STAFF RECOMMENDATION

NCPC File No. Z.C. 08-13

CONSOLIDATED PLANNED UNIT DEVELOPMENT AND MAP AMENDMENT MARRIOTT MARQUIS HOTEL

January 29, 2009

Public Space Section Detail
Massachusetts Avenue

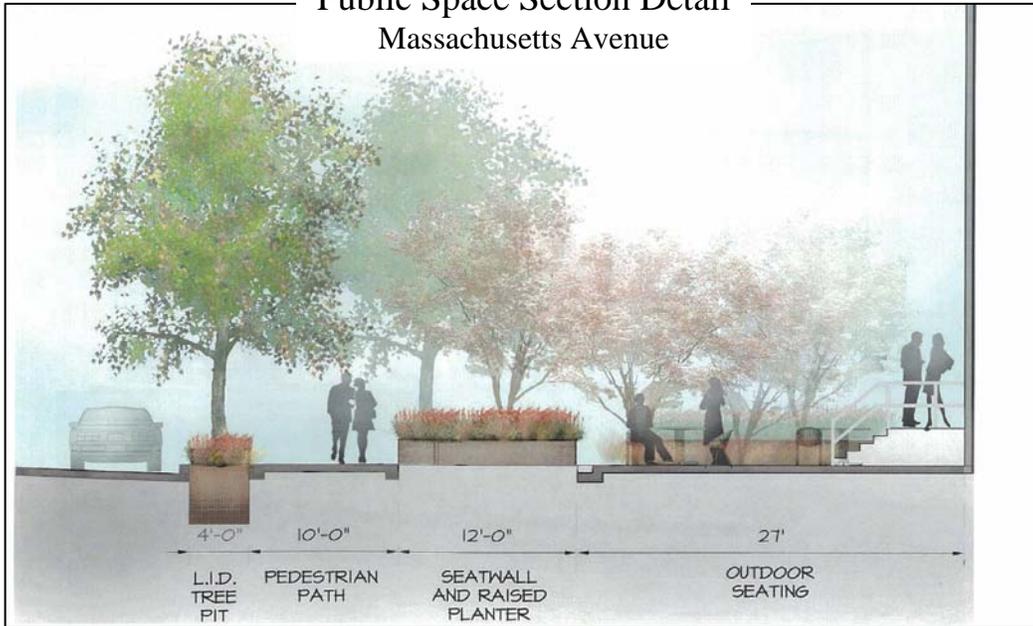
Use of the above ground portion of the proposal is an issue because the amount of space allocated for the sidewalk is only 10 feet, while the outdoor dining area is 27 feet plus 12 feet for a planting buffer with seat wall.

Staff has identified the width of the sidewalk and vehicle drop-off as concerns with respect to the proposed landscaping along Massachusetts Avenue, NW. Approximately 37 feet of the public space is outdoor dining or vehicle drop-off while the width of the sidewalk is 10 feet with a 4 foot tree planting strip. While this vehicular entry may be an allowable design response for a suburban location where land is plentiful, is not an appropriate response in an urban setting, especially given its location next to the D.C. Convention Center and along Massachusetts Avenue.

- Allow a sidewalk width along this portion of Massachusetts Avenue, NW that is consistent with sidewalk widths west of the site.
- Better integrate the outdoor dining space with the sidewalk.
- Reduce the amount of public space dedicated to vehicular movement along Massachusetts Avenue, NW, a L'Enfant street.

North-South Building Section

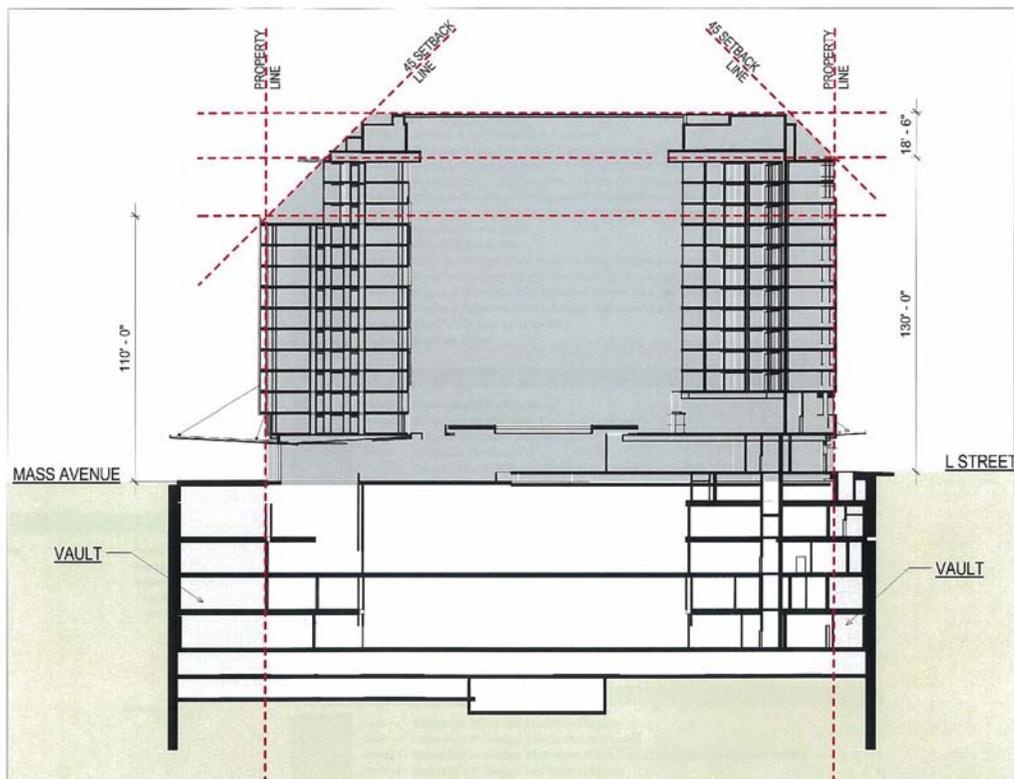
While this is allowed under the Height Act, the central atrium is enclosed (see North-South Building Section on previous page) and the top of the glass enclosure is 148.5 feet which is the same as the height of the penthouses. Staff understands that the current design is a modification from an earlier design and that this current roof height was chosen to ensure that it does not violate the Height Act.

Staff has determined that the atrium roof for this proposed building can be considered part of the penthouse because it is surrounded on four sides by the mechanical penthouse and does not exceed the penthouse height. In addition, the floor of the habitable space enclosed by the atrium roof is 14 floors below.

Staff finds that for these reasons the proposed building is in accordance with the provisions of the Height Act and no alterations are necessary.

Massachusetts Avenue Streetscape Detail

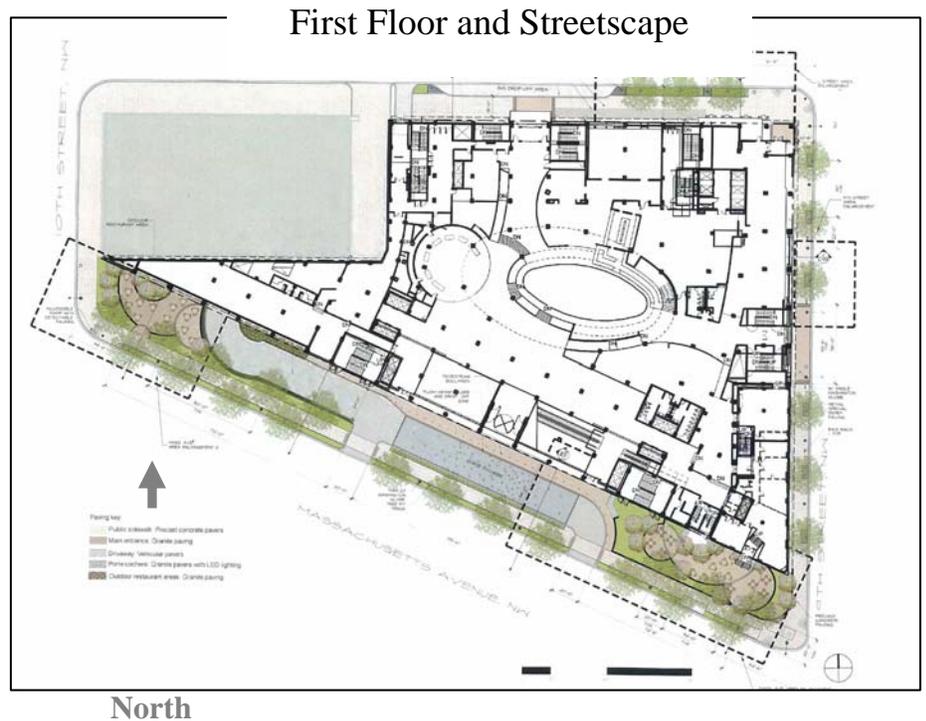
Staff finds that the current proposal for the design of the public space does not enhance the historic views along Massachusetts Avenue, protect the functional quality of the right-of-way, protect the openness of the street right-of-way or fully protect the integrity or design from physical incursions as identified in the Comprehensive Plan. This proposal will need to be modified to address these issues and alleviate these identified concerns.
